Building Address: 6781 Norris Lane
 City: Elkridge State: MD Zip Code: 21075
 Suite/Apt. # 9 SDP/WP/BA #: 0000
 Census Tract: _____ Subdivision: _____
 Section: _____ Area: _____ Lot: PAR 3
 Tax Map: 71 Parcel: 142 Grid: 12
 Zoning: R-ED Map Coordinates: _____ Lot Size: 12.7124 AC

Re: Revision to Building Permit No. B15000114 / 6781 Norris Lane, Elkridge, MD 21075

GREISMAN/GOSNELL RESIDENCE

REVISED
 Date: 8/4/15
 Comments: B15000114
 ALTERNATIVE LAYOUTS
 TO ATTIC + 2ND FLOOR
 (NO STRUCTURAL CHANGES)

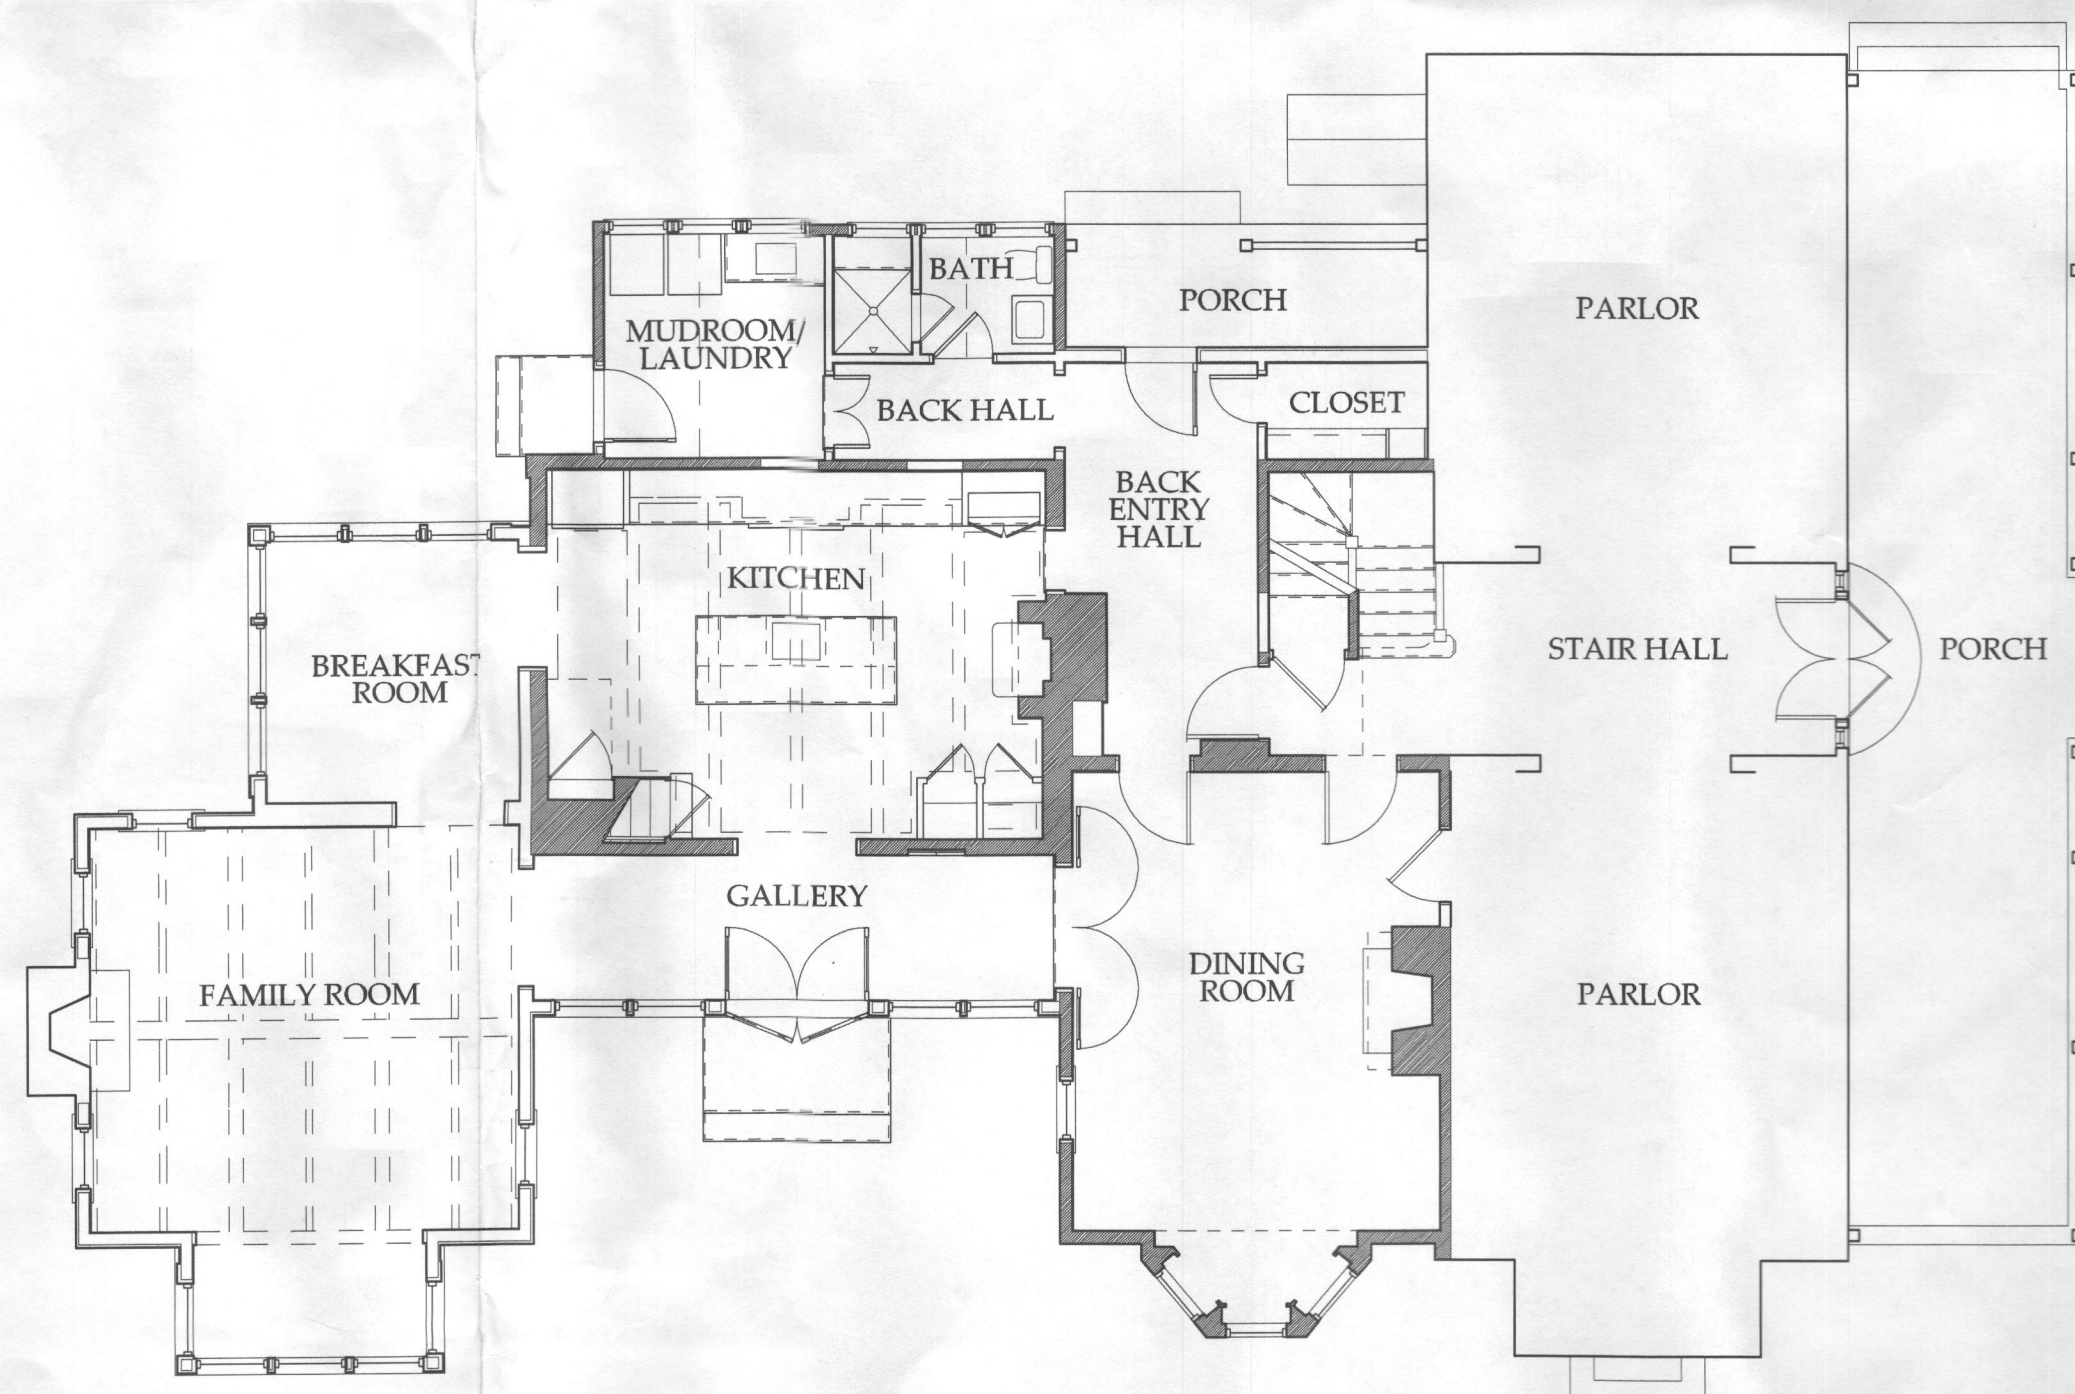
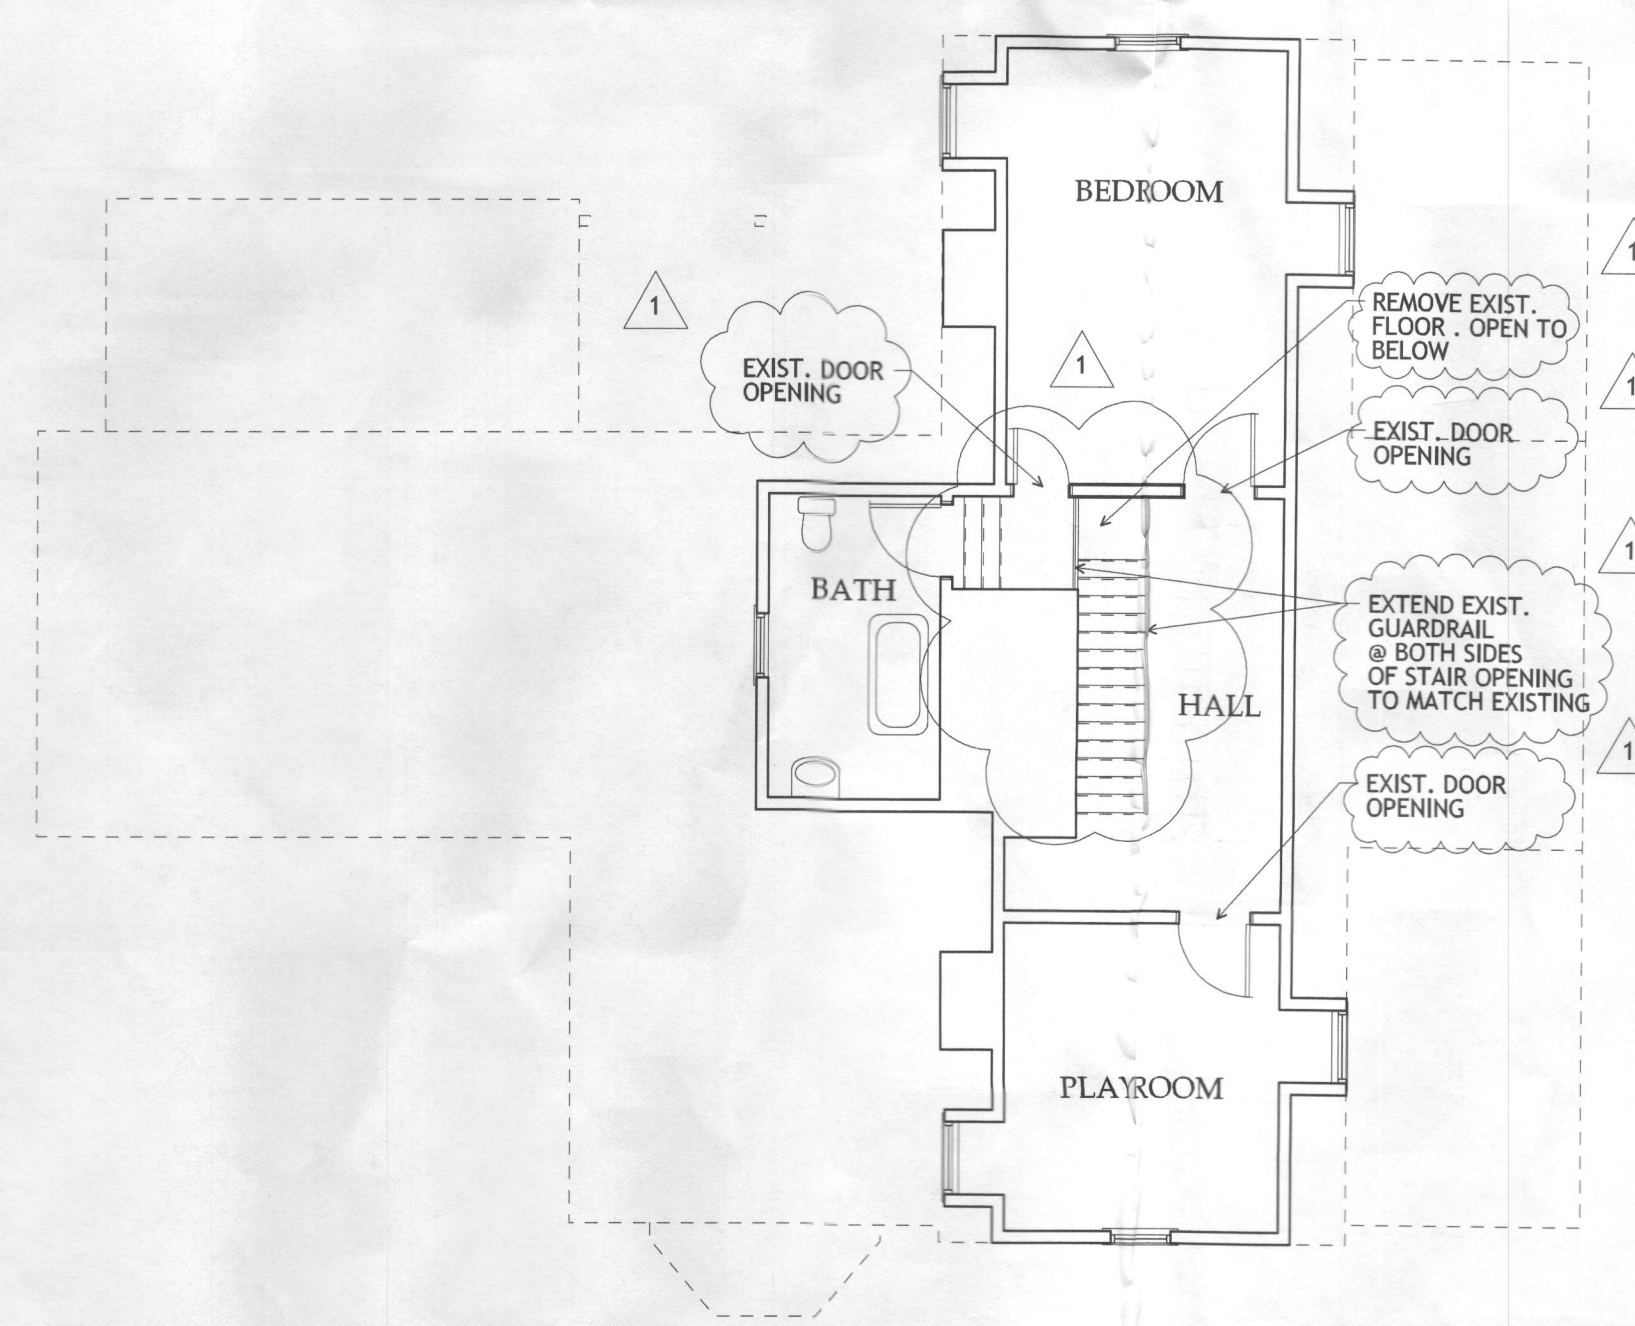
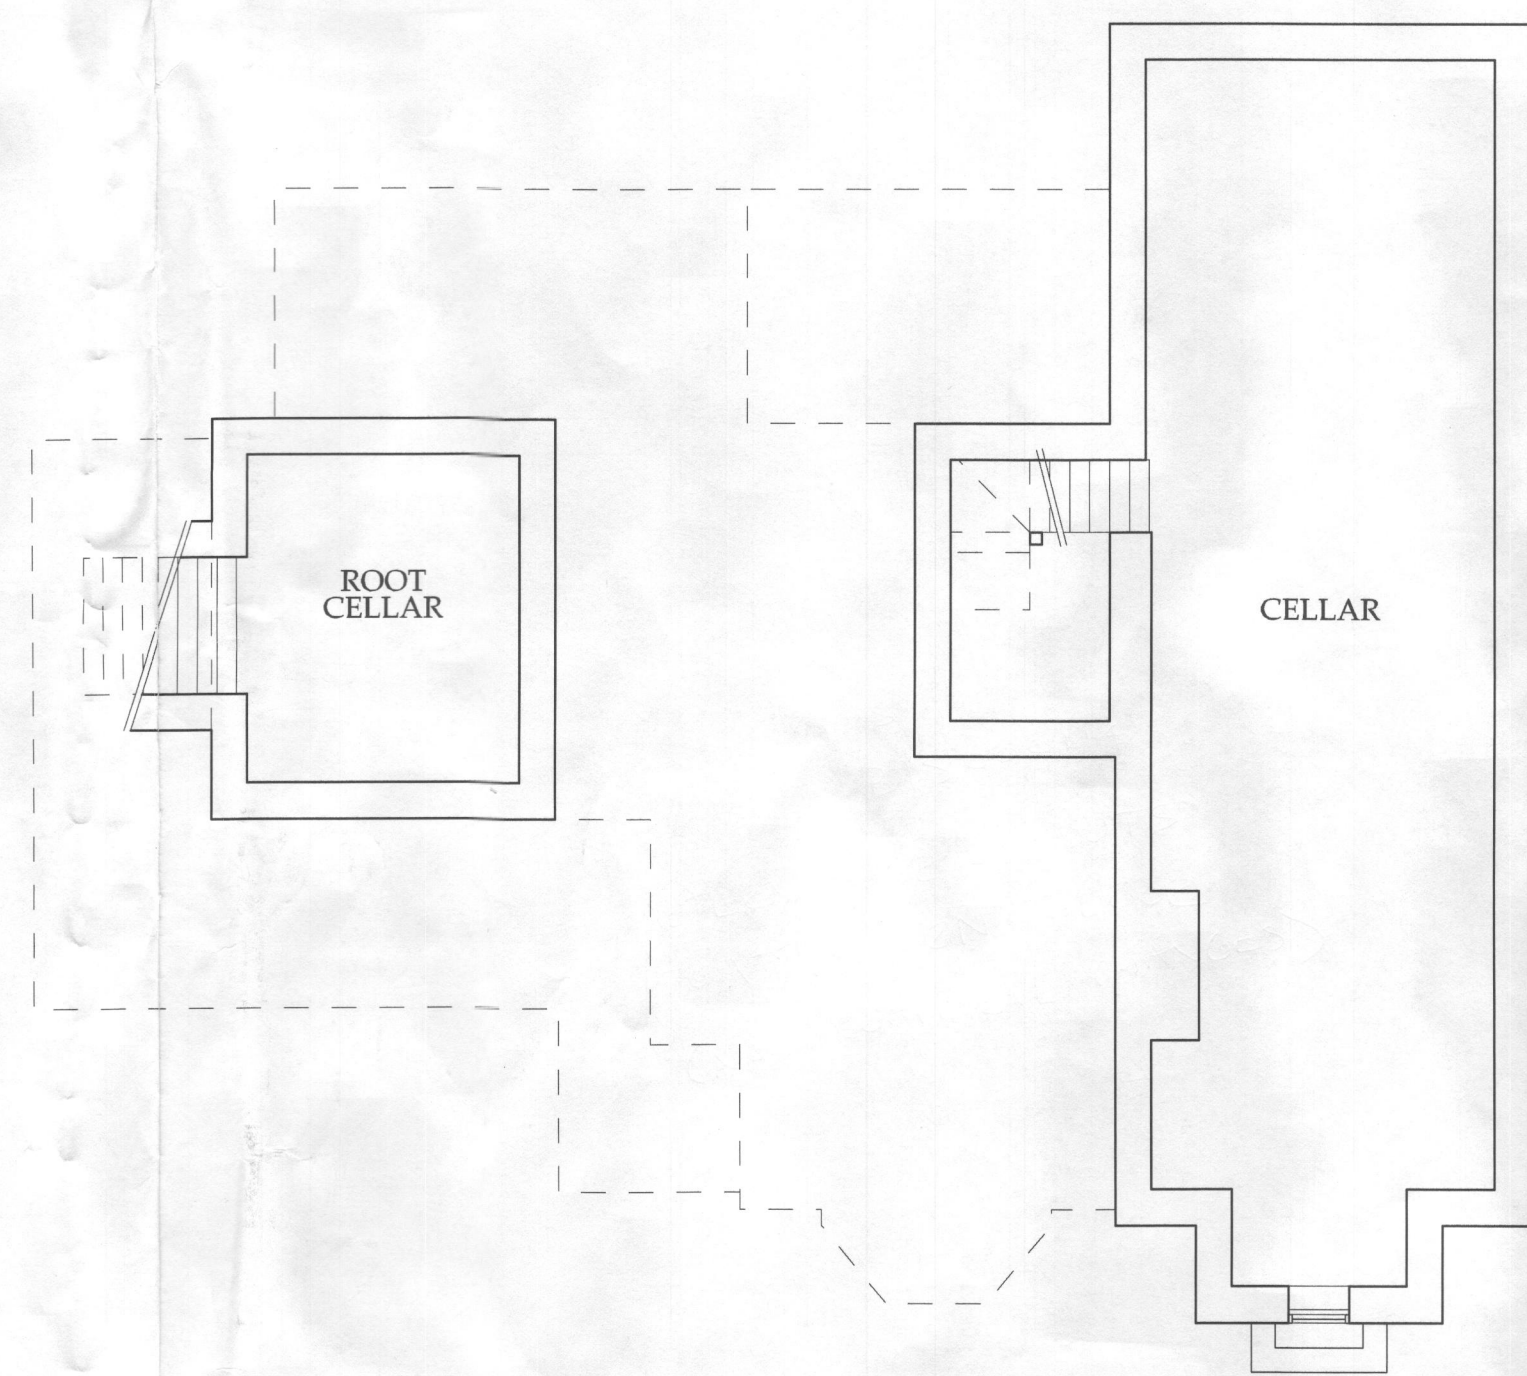
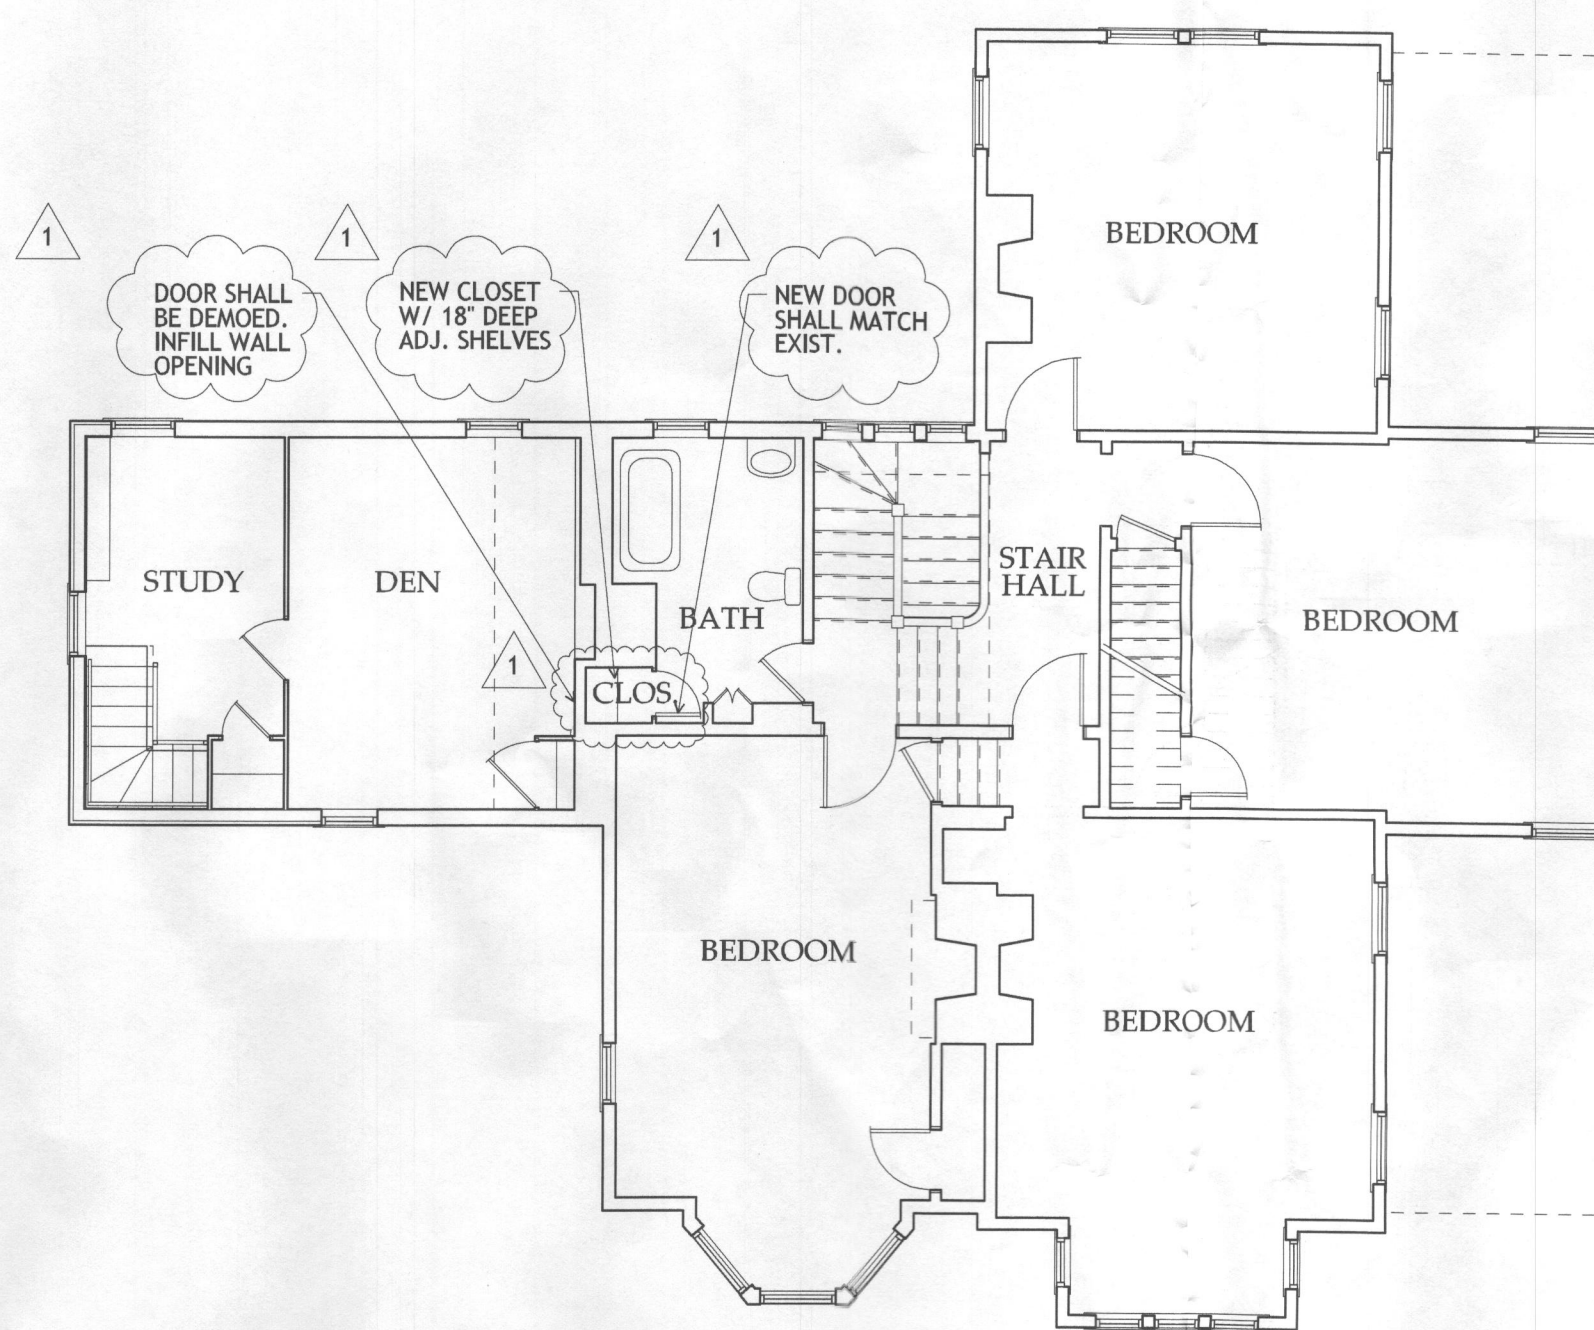
Attached please find three copies of drawing sheet A 1.1.1 for approved building permit number B15000114. We request that the attached drawing be submitted as a revision to the original sheet in the approved permit set. The revised drawing represents an alternative layout to the second and attic floors of the single family residence that limit the number of bedrooms to 5, which meets the capacity of the existing septic system. The Health Department has previewed this layout and agrees that the modifications proposed meet their criteria for distinguishing bedrooms from other spaces. The Health Department reviewer directed us to submit the floor plan revisions as a permit revision so they could officially approve this layout for construction.

The changes are focused to the second floor and attic levels. On the second floor, they propose blocking off one of the originally designated bedrooms over the new Kitchen from its direct access to the second floor hall bath. The doorway would be filled in and the passageway would be converted into a closet accessed from the bathroom only. This former bedroom would now not have direct access to a bathroom on the second floor. We are calling this former bedroom a den in the proposed plan revision.

On the attic level, the owner proposes removing the flooring that bridges over the stair going down to the second floor so that the room we had called an office in the permit set would now be isolated from having access to the attic bathroom. This turns the room we called a playroom in the permit set back to a bedroom with its access to the attic bath.

I filed the drawing sheet at the Permit office this morning that shows all the floor plans for the house on it and identifies the five bedrooms on the second floor and the two attic rooms with the door removed and openings widened to 4 feet. Please let me know if any additional information is needed. We would greatly appreciate a quick review and hopeful approval.
